TOWN OF WATERBURY ZONING PERMIT APPLICATION

Date:	<u>5/20/2021</u>	Application #:	<u>049-21</u>
Fees Paid:	<u>\$300</u>	+ \$15 recording fee =	<u>\$315</u>
Parcel ID #:	<u>400-2382</u>		
Tax Map #:	<u>13-249.000</u>

BROWN/COLON

**Statement of Billy Vigdor
To the Waterbury Development Review Board (DRB)
Regarding Application 49-21
July 7, 2021 (corrected version)**

**Exhibit 1 – Perry Hill Project Overview
(Annotated to Illustrate the Extent of the Wooded Double Track Access Road)**

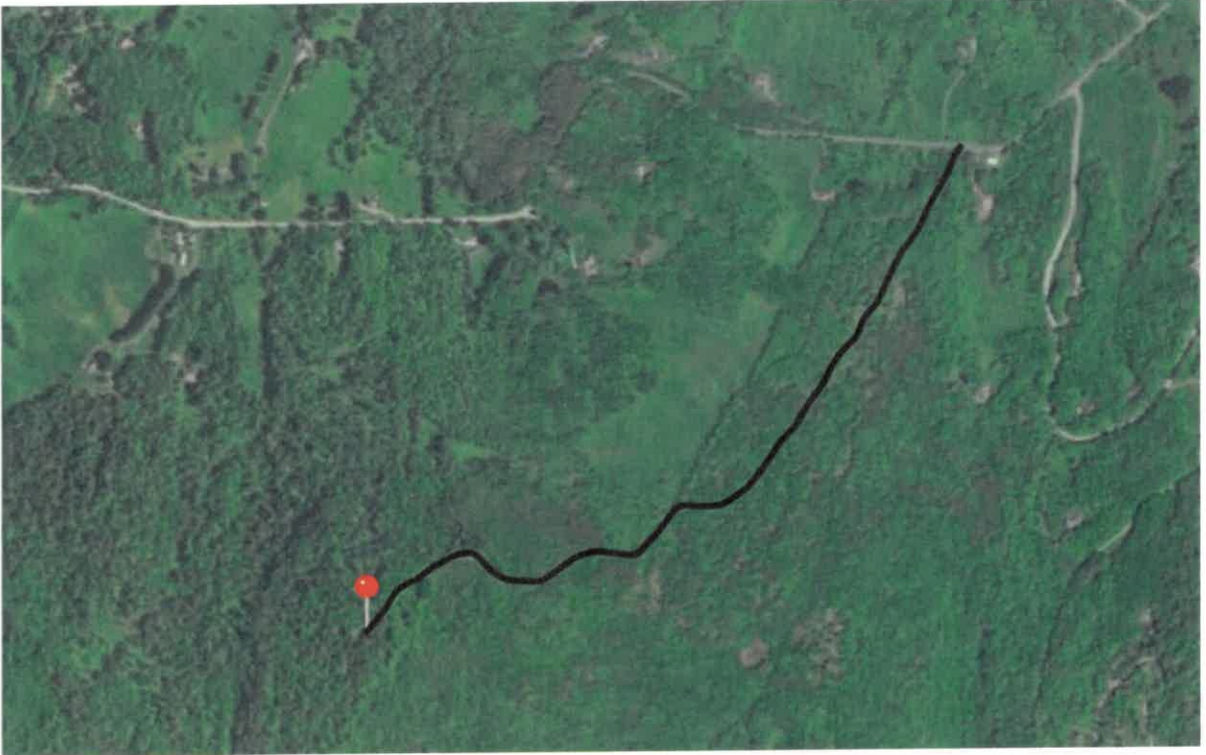
Let me start by showing you Perry Hill and the property. Exhibit 1 is a June 25, 2021 Apple Maps view of Perry Hill and the proposed project, annotated to show the .7-mile access trail from Perry Hill Road. The Exhibit shows the proposed project is within hundreds of heavily forested acres. Exhibit 2 provides Agency of Natural Resources data showing Perry Hill, other than the proposed project, is entered into the Use Appraisal (Current Use) Program.¹ Exhibit 3 shows the property accesses Perry Hill Road using a heavily forested and vegetated double track. The trail is about .7-miles from Perry Hill to the closest part of the property and averages about 13 feet wide with grades as steep as 12.5%. Water bars have been erected to prevent erosion on the steeper parts of the trail.
